RENESAS TECHNICAL UPDATE

Product Category	Package	Document No.	TN-WRP-A002A/E	Rev.	1.0
Title	Spec change of packing (RENESAS unified packing specification)	Information Category	Packing Change		
Applicable Product	All shipped products of which packing are the following (1), (2) and (3).	Lot No.	-		
		Reference Document	-

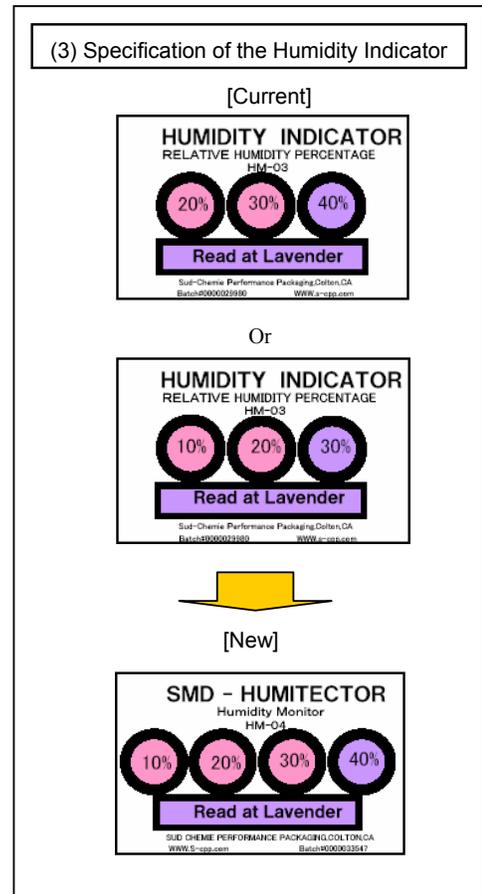
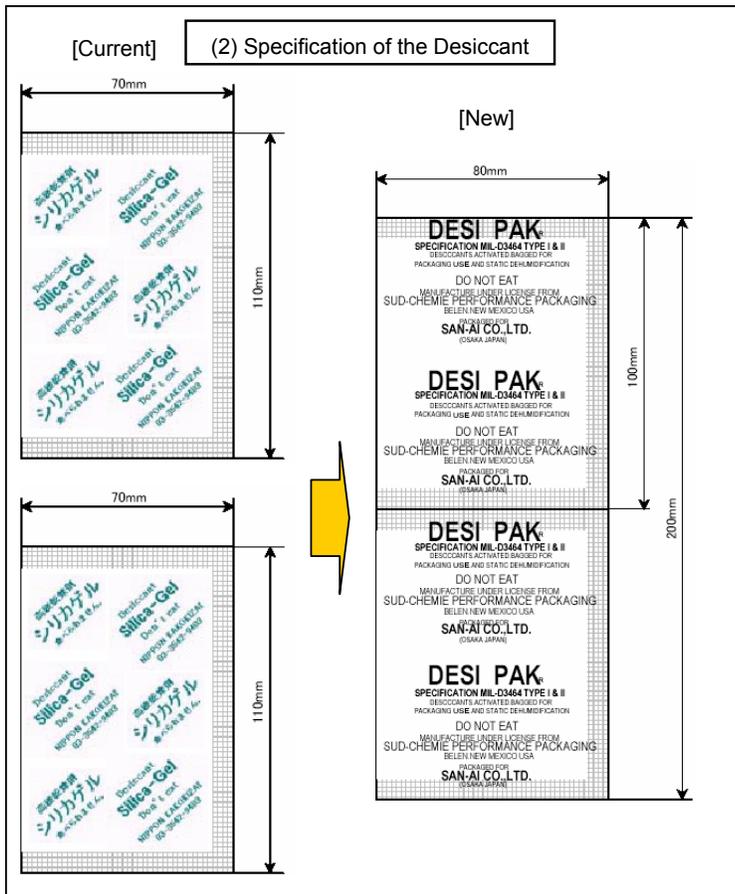
#	Item	[Current] Current packing specification	[New] New packing specification
(1)	Color of PP band	Pink	White
(2)	Desiccant	"Silica-Gel" x 2packs (50g in total)	1 pair of "DESI PAK" (50g in total)
(3)	Value of Humidity Indicator	3-value indicator: [10, 20,30%] or [20,30,40%]	4-value indicator: [10,20,30,40%]

- 3.1 There would be No difference in strength of the band, since we changed the color only and the band itself is a product of same grade as the current one, which is made by the same manufacturer.
- 3.2 The new humidity indicators are made by same manufacturer. We change the number of values only.
- 3.3 We confirmed that the DESI PAK's performance is better than the "Silica-Gel".

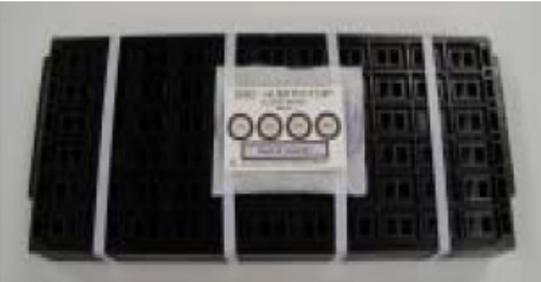
We would like to apply the C specification after May 2005 gradually to products that has been shipped by A specification currently. (Described on Page1 and 2)

On the other hand, the product delivered by B specification will not have any changes, but for new product after February, 2005 C specification will be applied gradually, excluding the Full-carton specification.
